ARCHITECTURAL REVIEW BOARD MEETING

PROJECT COMMENTS

PROJECT NUMBER: SP2024-046
PROJECT NAME: Site Plan for 2686 S. Goliad Street
SITE ADDRESS/LOCATIONS: 2686 S GOLIAD ST

PROJECT NUMBER: SP2024-048
PROJECT NAME: Site Plan for River Dog Retreat
SITE ADDRESS/LOCATIONS: 100 S JOHN KING BLVD, ROCKWALL, TX 75087

1 NORTH ELEVATION
SCALE: 3/16" = 1'-0"

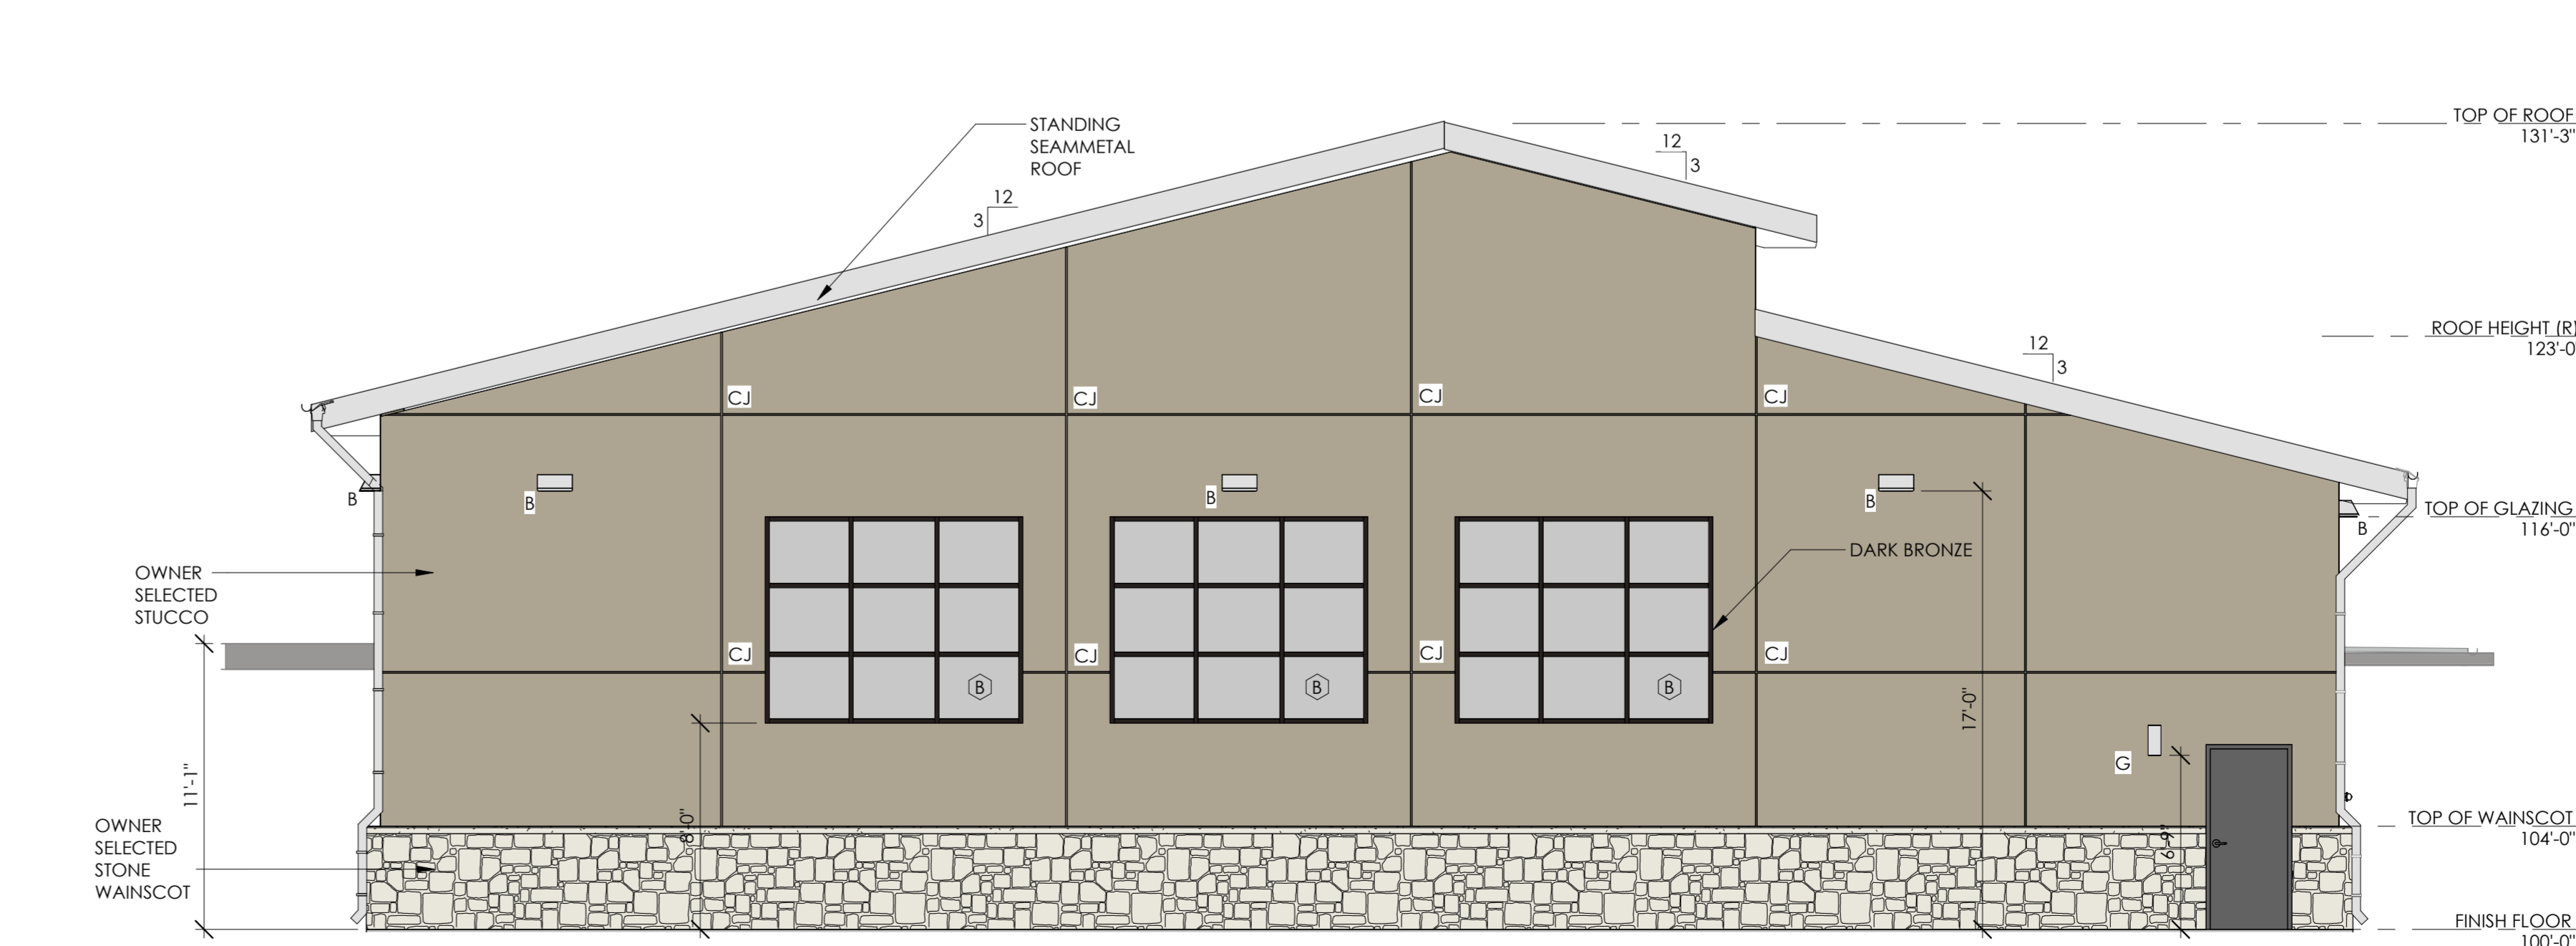
- (1) Please update the table indicating the percentage surface area for each of the proposed materials. This should not include the roof. This will change the material percentages for the stone and stucco. Based on this, the stone may be over the 20% stone requirements (Subsection 04.01, of Article 05, UDC)

- (6) Please provide building elevations for the existing basketball court facility. (Subsection 03.04.B, of Article 11, UDC)

JOB NO.	3036-21	DESIGN BY	BS
CREATED		CODE	
PLOTTED	11/14/2024	CHECKED BY	BS
LAST UPDATE BY			
DRAWN:	MW	SCALE:	AS NOTED
CHECKED:		DRAWING NO.:	ISSUE:
APPROVED:		LP-1	0
FILENAME:

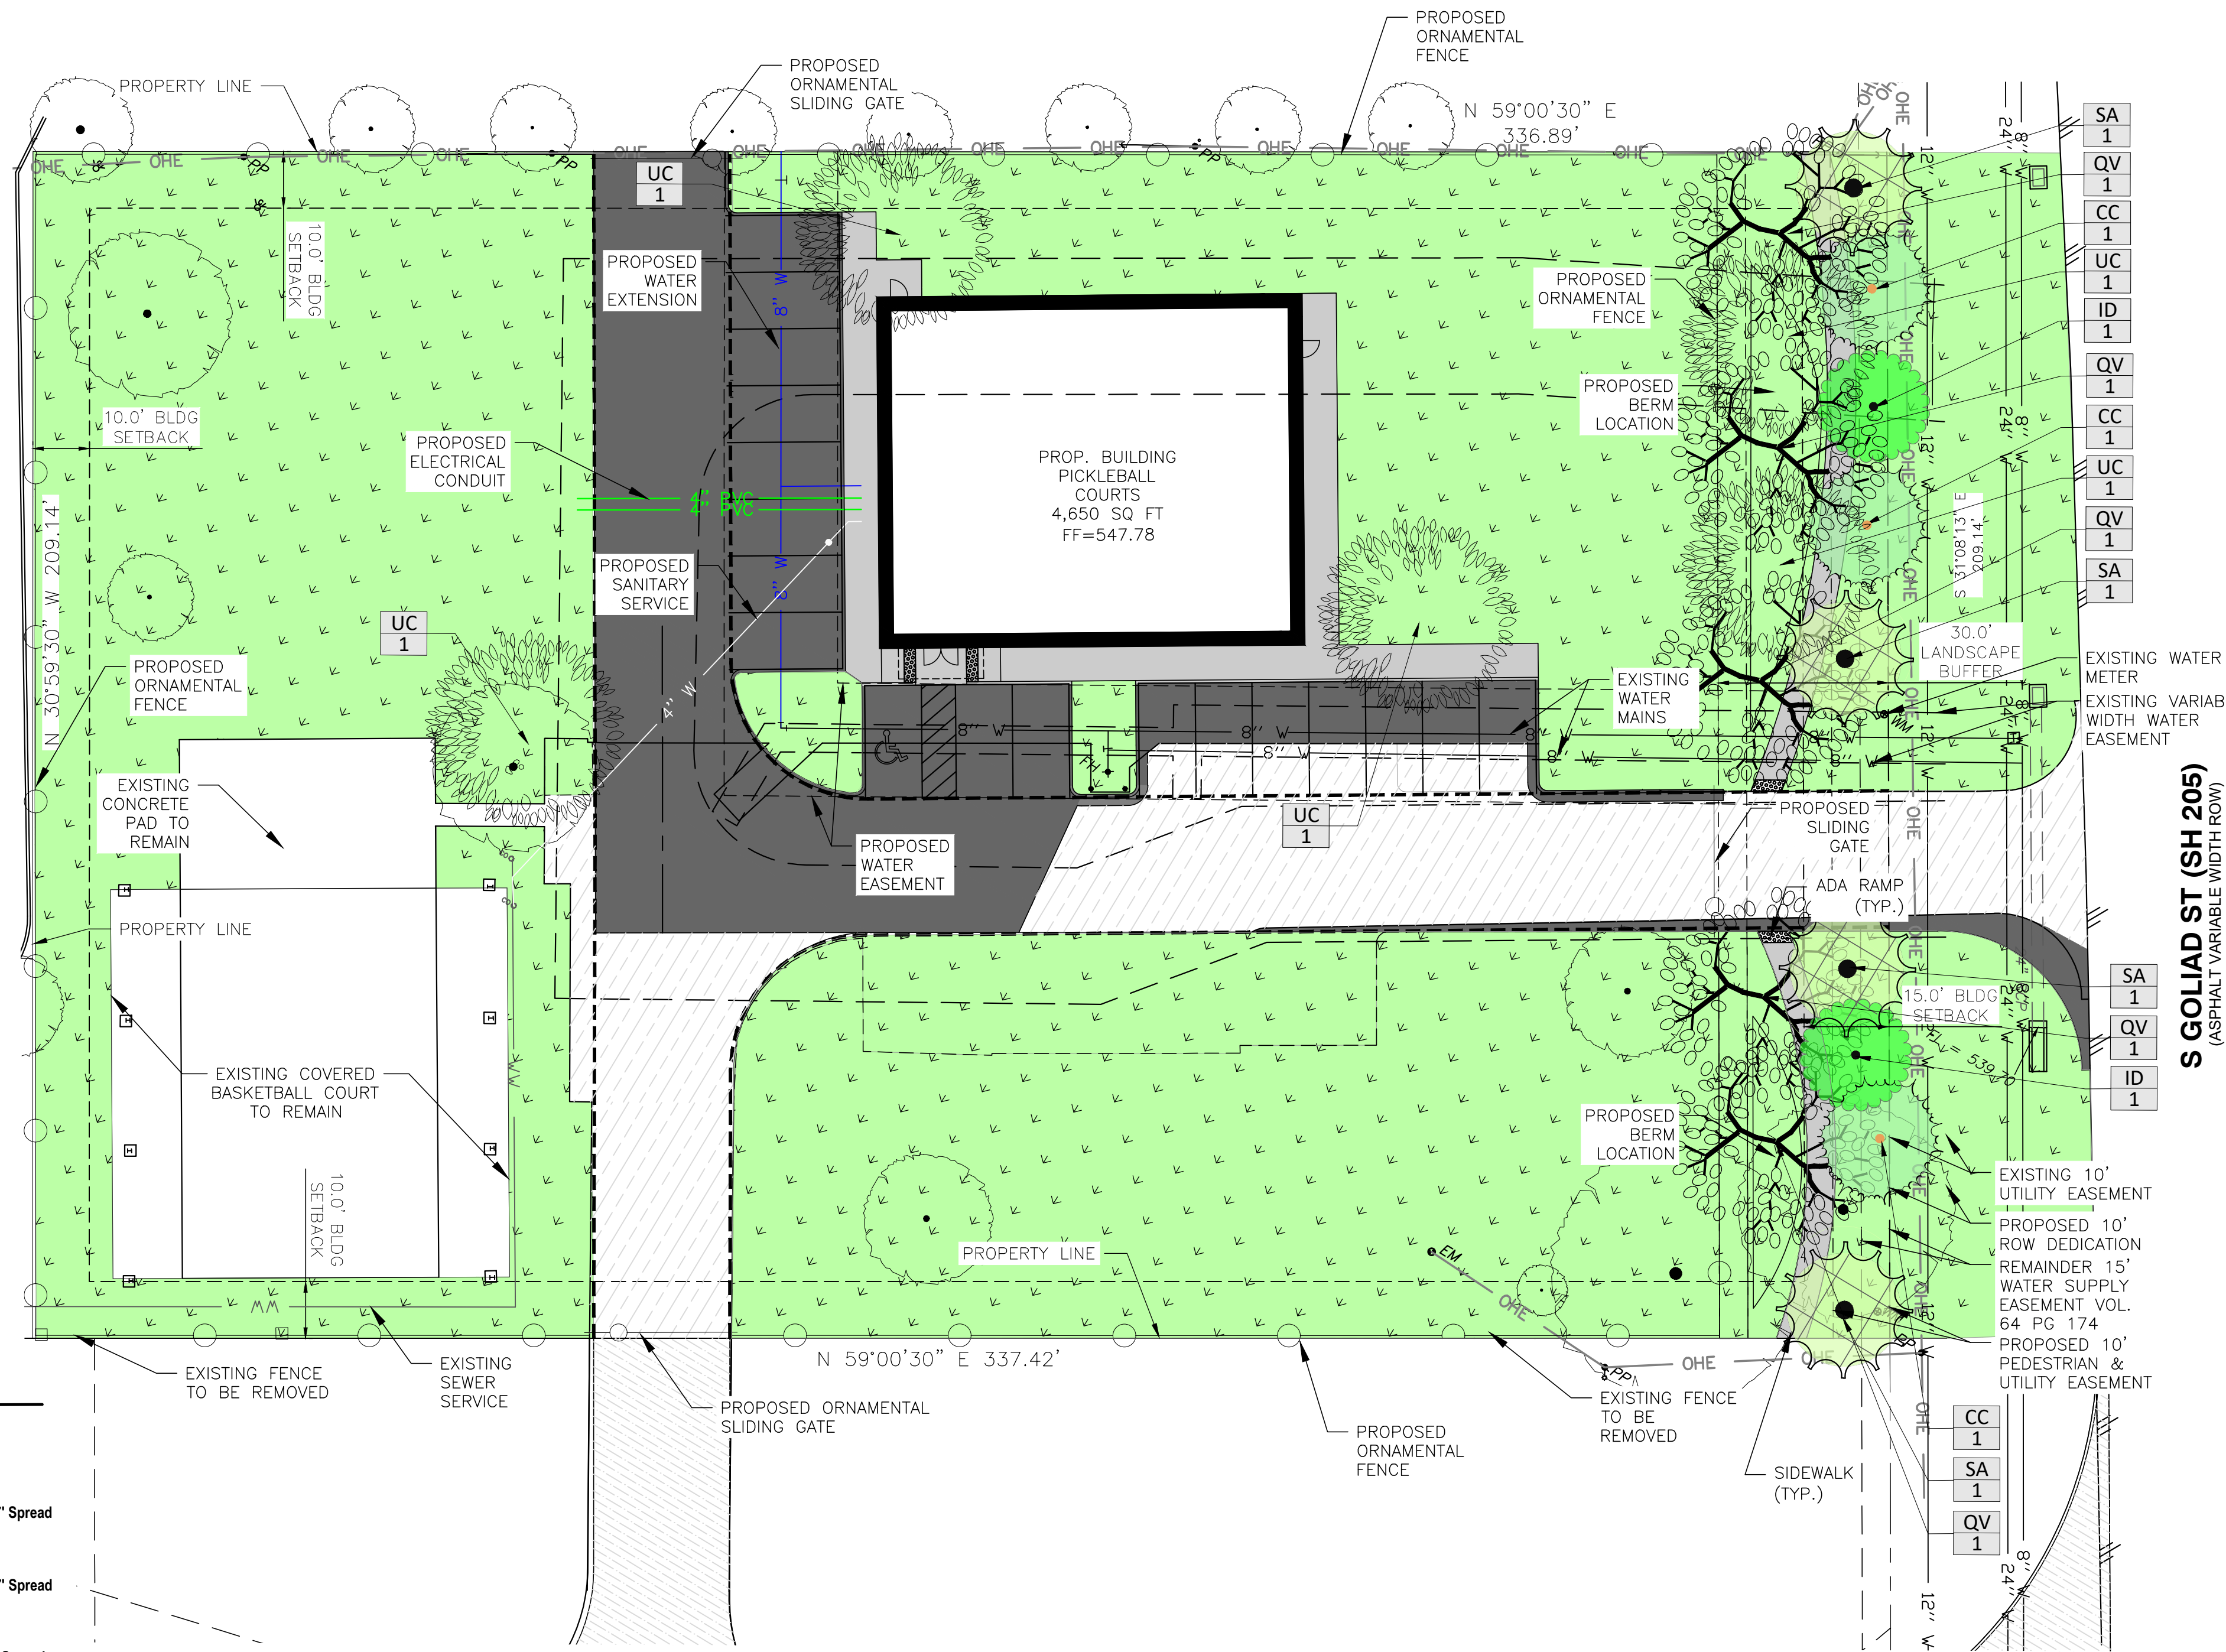
- (1) Please delineate and label the 25-foot landscape buffer along S. Goliad Street. (Subsection 05.01, of Article 08, UDC)
- (2) Per the Planned Development District 44 (PD-44) Ordinance, "berms and shrubbery shall have a minimum combined height of 48-inches." Please delineate the berm on the landscape plan and provide the required shrubs. (PD-44, Ordinance No. 24-30)

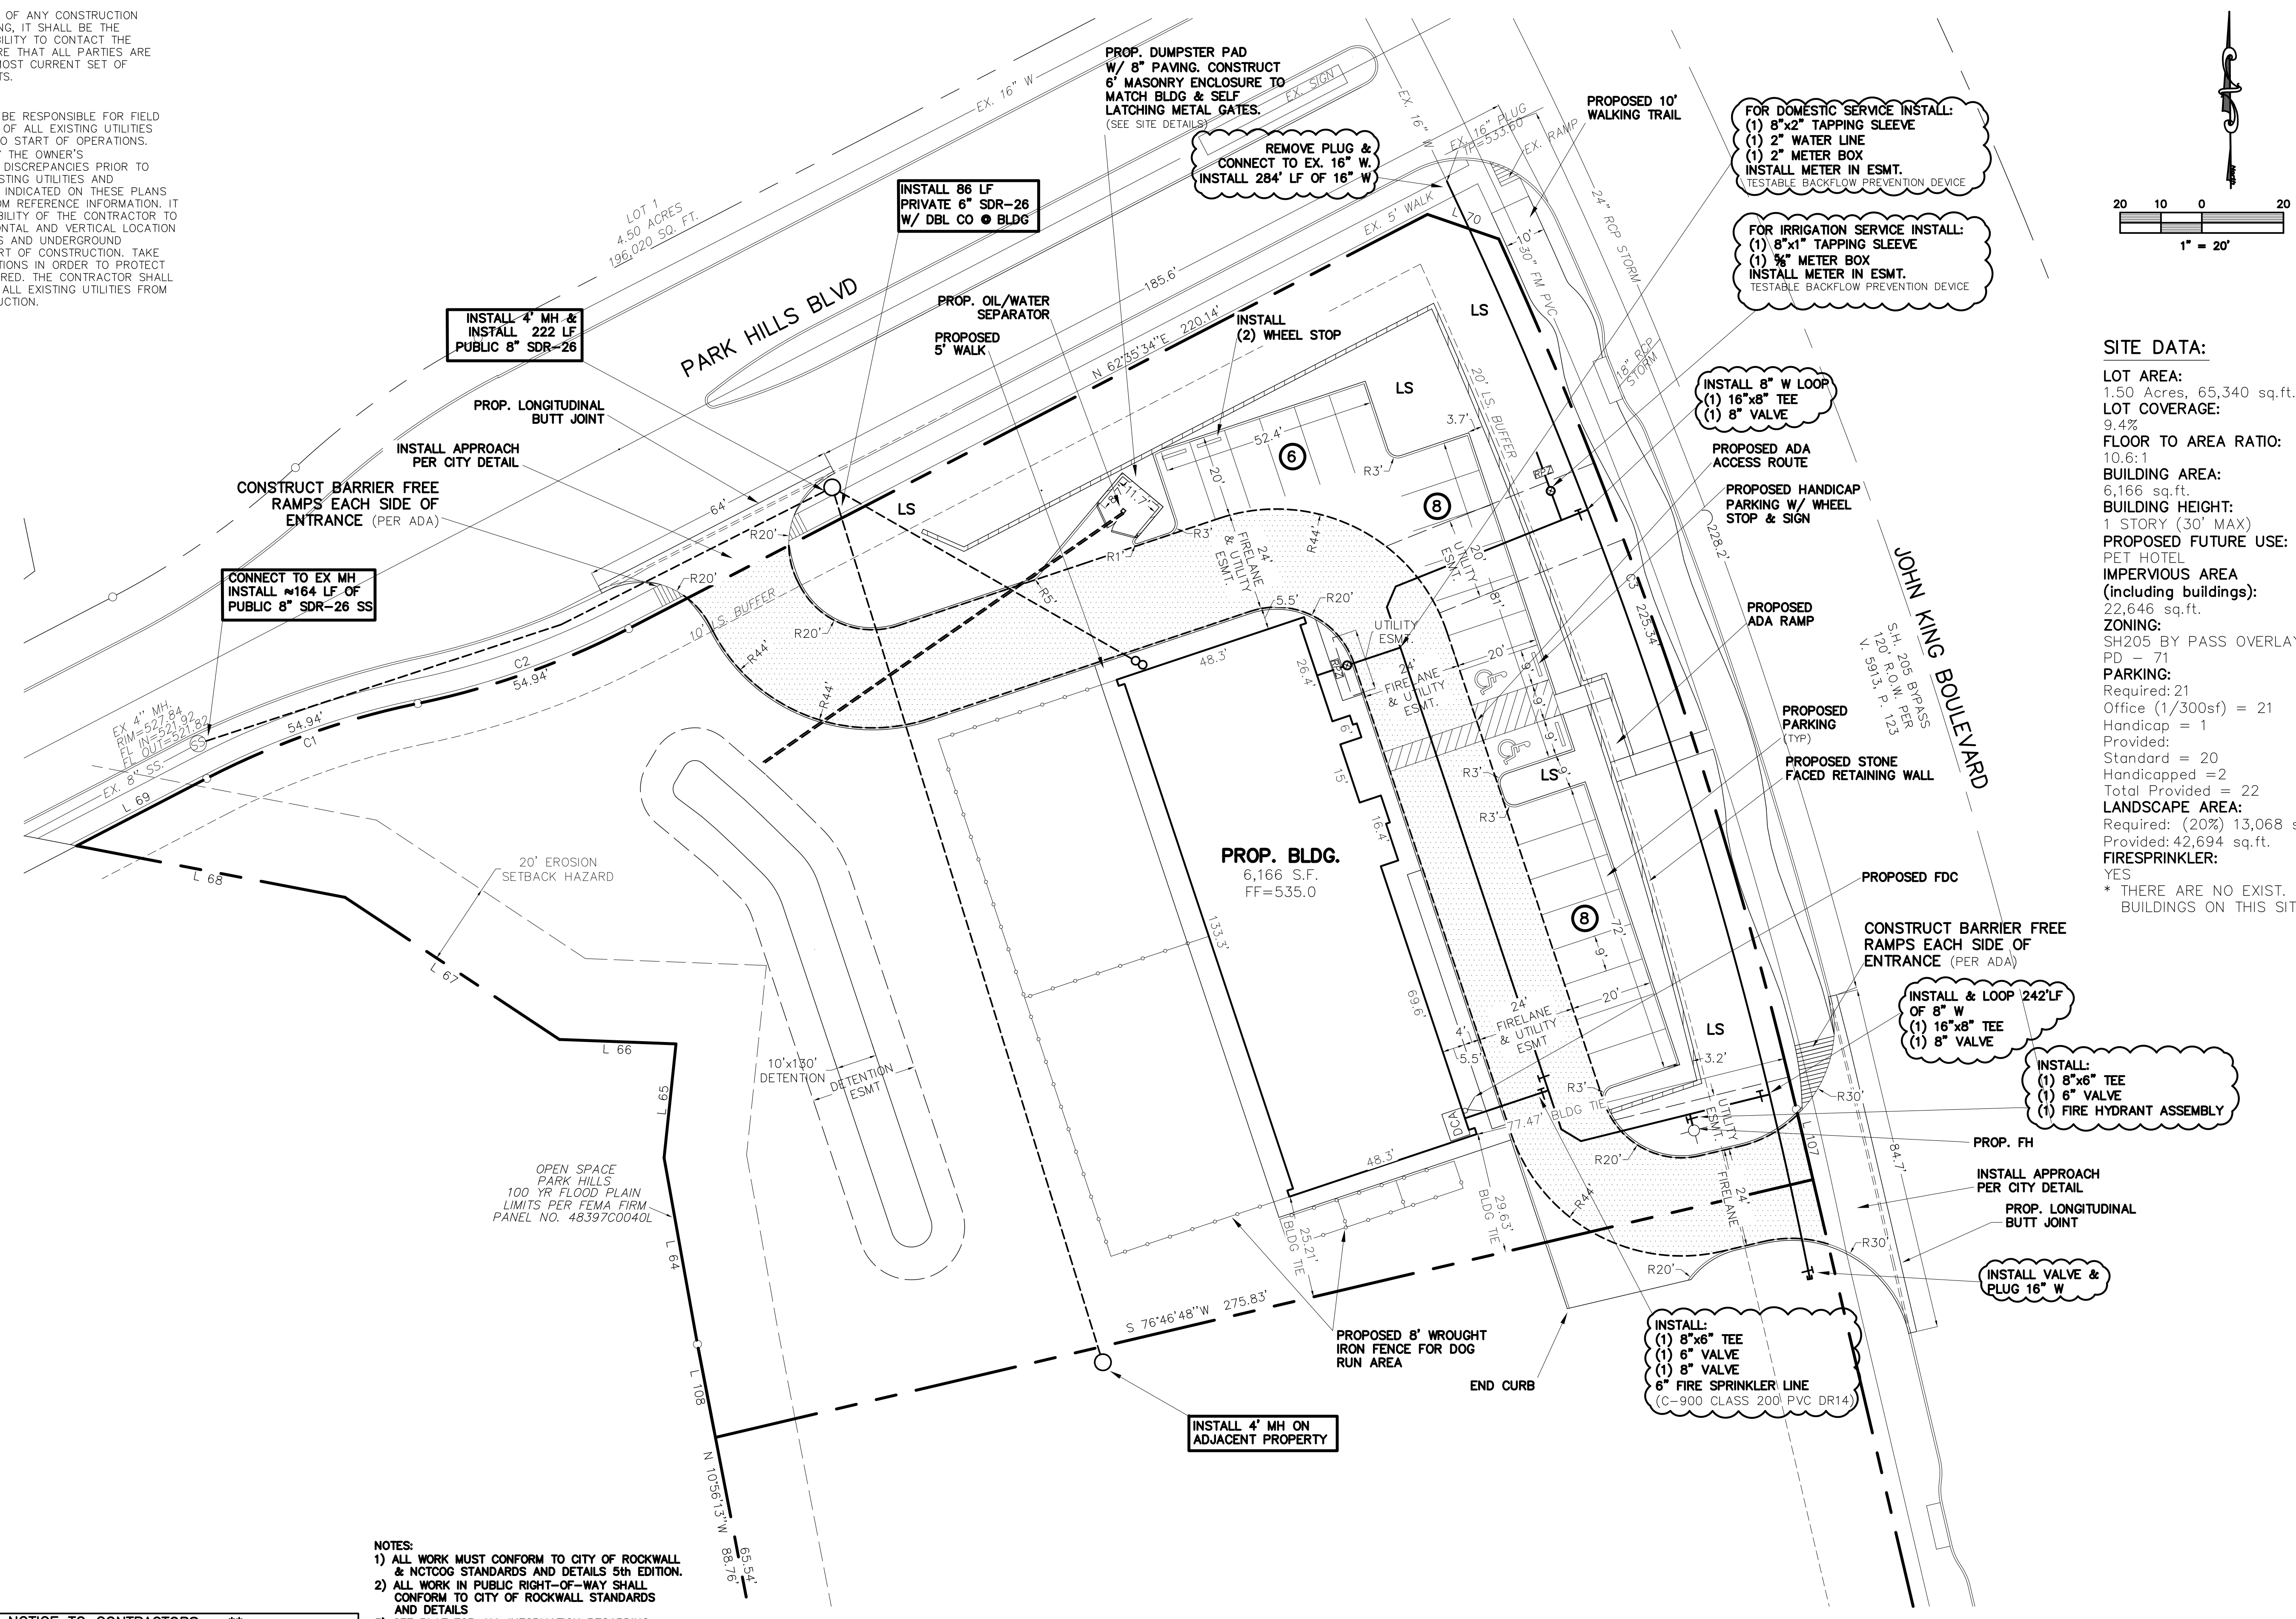
- (2) The vicinity map depicts the incorrect location. Please correct this. (Subsection 03.04.B, of Article 11, UDC)
- (3) Please label and delineate the building setbacks along John King Boulevard (i.e. 25-feet) and Park Hills Boulevard (i.e. 15-feet). (Subsection 03.04.B, of Article 11, UDC)

- (6) Please clarify the estimated retaining wall height. Retaining walls within an overlay district are required to be terraced; every four (4) feet in height a two (2) wide planting bed must be provided. (Subsection 06.02.E.3, of Article 05, UDC)

- (8) This project would be parked at Retail and not Office, at 1/250 SF, for a total of 25 parking spaces. (Table 5, of Article 06, UDC)
- (9) Indicate the type and depth of the paving material and provide a detail or cut-sheet. (Subsection 03.02, of Article 06, UDC)

- (12) All pad mounted equipment must be shown on the site plan. This equipment must be screened with five (5) gallon evergreen shrubs, which should be shown on the landscape plan. (Subsection 01.05.C, of Article 05, UDC)

- (13) Will there be any equipment within the play yards? This equipment must be delineated on the site plan. In addition, elevations or specs for the equipment must be provided. (Subsection 01.05.C, of Article 05, UDC)

- (14) The canopies in the play areas shall be permanent and not temporary (i.e. not movable). Their location and size must be tied down through the site plan. This will be an exception. (Subsection 01.05.C, of Article 05, UDC)

- (15) Please provide a note that there will be no above ground storage tanks. (Subsection 01.05.D, of Article 05, UDC)
- (16) All dumpster enclosures must be 12-feet by 10-feet, and within the overlay district they must be 8-feet in height. Please correct the site plan and dumpster detail to reflect this. In addition, please denote that the brick on the enclosure will match the primary building. (Subsection 01.05.B, of Article 05, UDC)
